Glass Manufacturing Plants
Background Information for Promulgated
Standards of Performance

EPA-450/3-79-005b
September 1980

Background Information
and Final
Environmental Impact Statement
for Glass Manufacturing Plants

FIGURE 1. IMPACT DECISION FLOW CHART

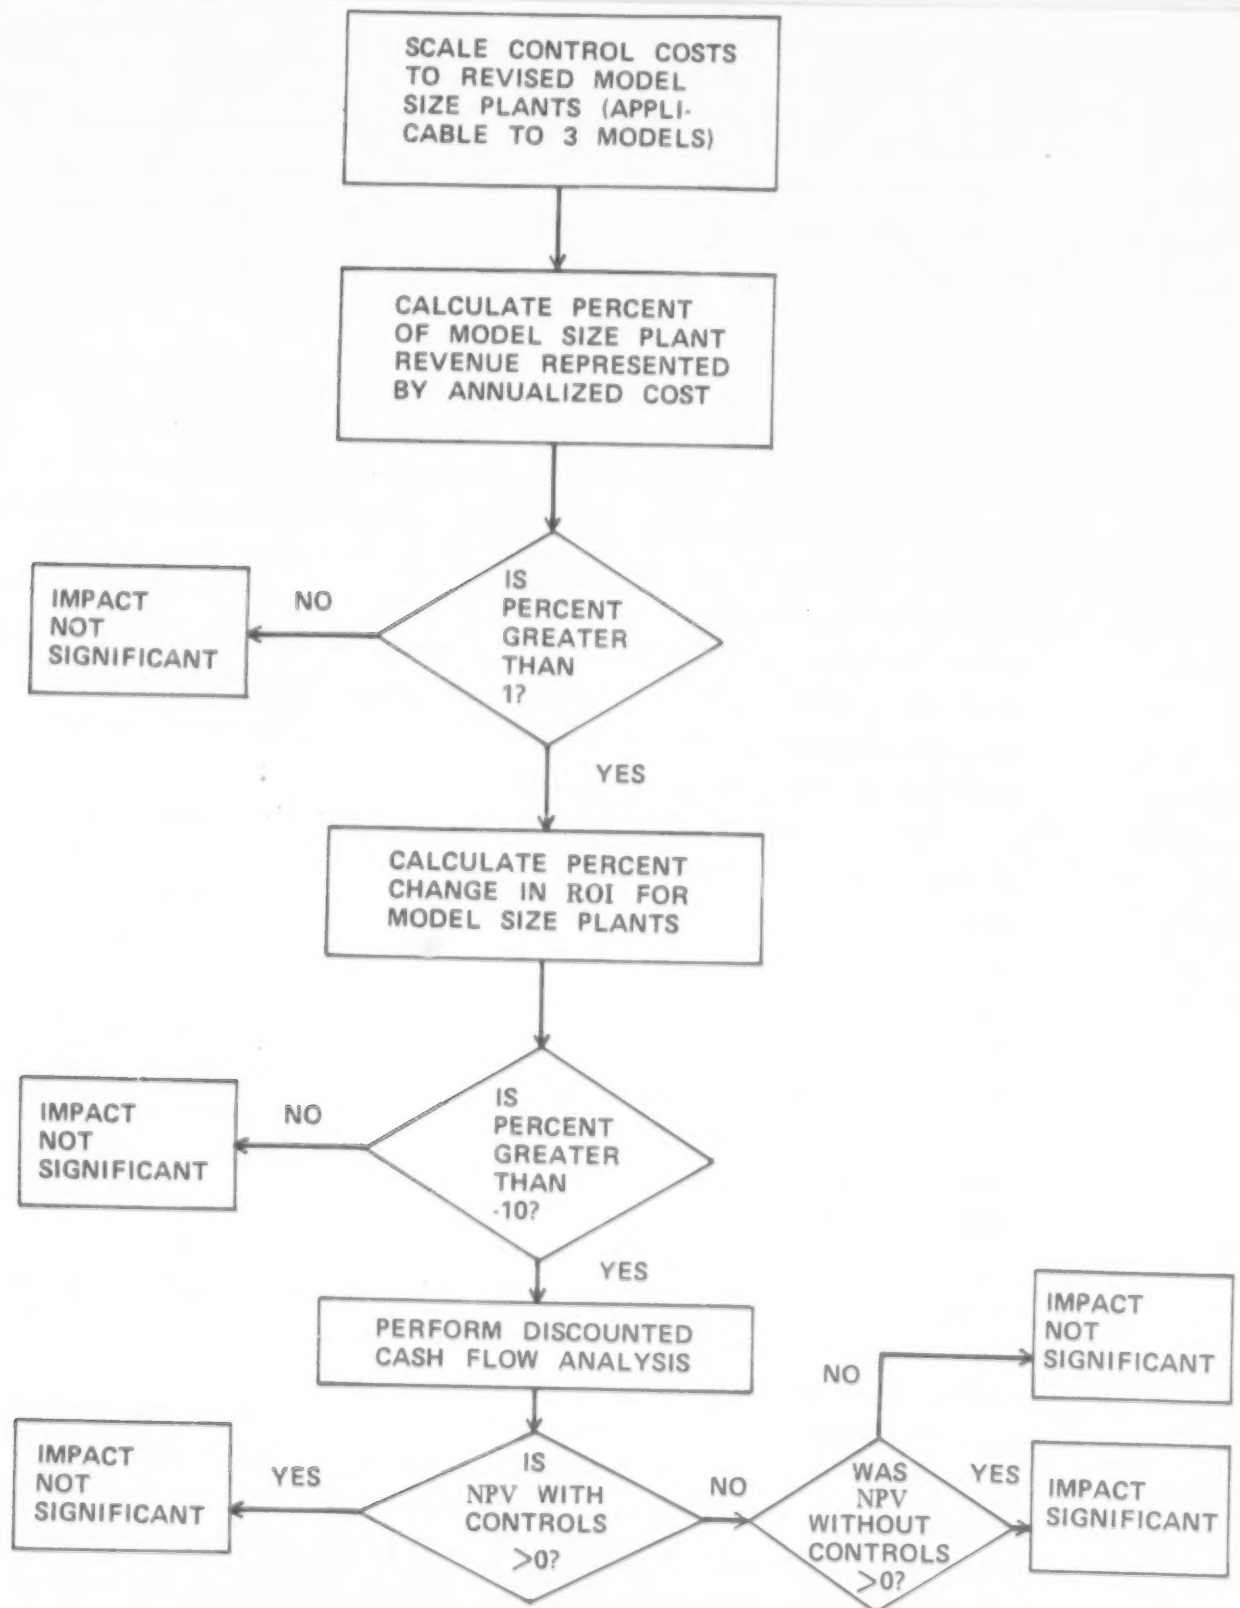
Other commenters stated that process modifications were more cost-effective than the controls analyzed and that process modifications should be the basis upon which the standards are set. (Refer to the discussion on process modifications in the Emission Control Technology section of this document.) Process modifications are not precluded from use as a method of compliance with a NSPS. If they are indeed more cost-effective than those regulatory alternatives analyzed then those sources that can utilize process modifications will experience lesser impacts than those estimated in the regulatory analysis.

One commenter suggested that more weight should be given to economic costs than a mere determination that the industry can bear the costs of a control technique and still survive. The comment appears to refer to the focus of the discounted cash flow (DCF) technique on whether or not controls will inhibit the building of new glass manufacturing plants. The use of the DCF was limited to special cases where survival might have been in question. However, for most of the glass manufacturing categories the DCF analysis was not needed because the impact of the standards does not approach the point where survival might be in question. For example, the industry average price increase is less than 1 percent, a price increase that would not deter the construction of any new plants by itself.

A review of the economic impact analysis may be helpful. Figure 1 is a flow chart description of the decision-making process used in evaluating the Economic Impact Assessment of the New Source Performance Standards (NSPS) for glass manufacturing plants. The first step called for a scaling of certain model plant control costs to obtain control costs for other plant sizes suggested by industry as not being covered by the model plant sizes. The next step in the calculations was to determine the percent of plant revenue represented by the annualized control cost for each model and the other sized plants. The control costs selected for these calculations were for the highest-cost for a regulatory alternative. The purpose of this step was to determine the price increase potential of the controls if costs are passed on to the consumer, or the profit reduction that would occur with no product price increases. Revenue was determined on the basis of the capacity, capacity utilization rate, and price per unit of output determined for that particular industry category.
